Application by Waterford County Council for Waste Licence Application  
W0032-03 for Dungarvan Landfill, County Waterford

Replies to Request for further information in  
accordance with Article 14(2)(b)(ii) of the Waste  
Management Regulations

Client	Waterford County Council					
Project Title	Dungarvan Landfill Remediation Works					
Document Title	Waste Licence Application W0032-03 Article 14 Response					
Document No.	MDR0450Rp1033					
This Document Comprises	DCS	TOCs	Text	List of Tables	List of Figures	No. of Appendices
	1	1	4	-	-	4

Drawing Number: **MDR0350/DG0505**

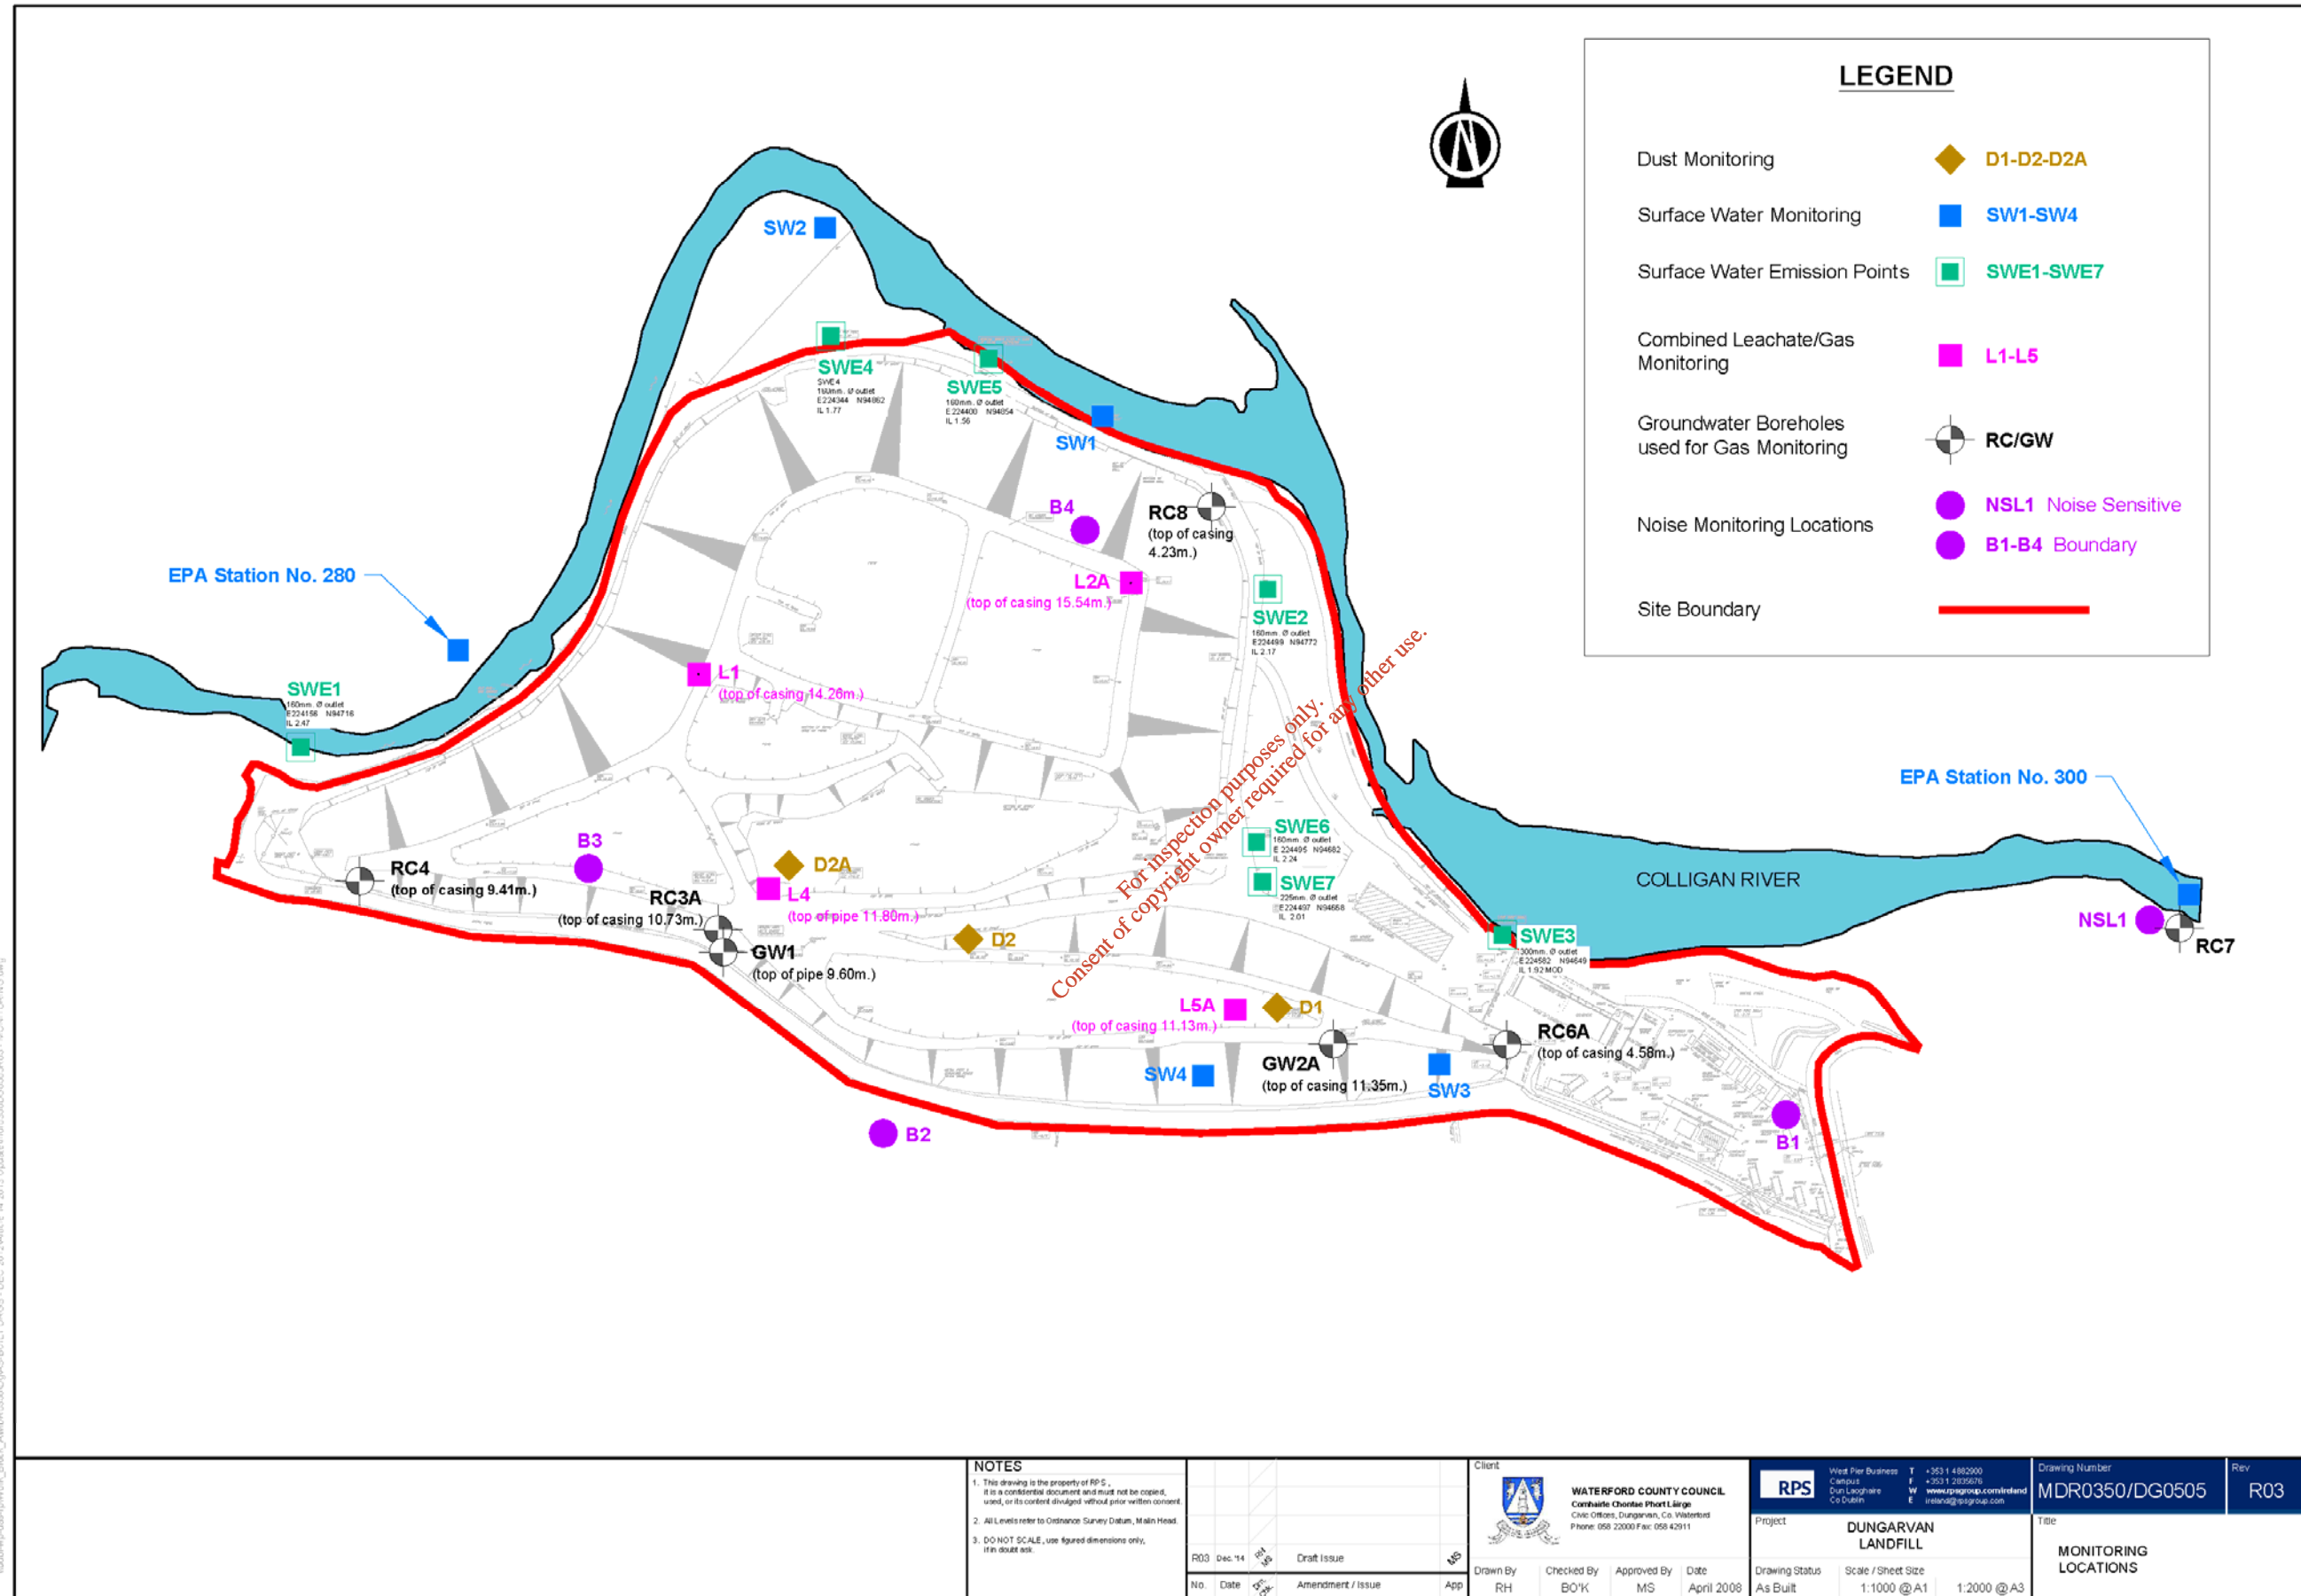
*Submit a new drawing, to replace all earlier drawings, some of which are contradictory, showing monitoring locations within and outside the site boundary. Include their symbols and grid reference numbers.*

A revised drawing MDR0350/DG0505R03 has been included in Appendix 4.
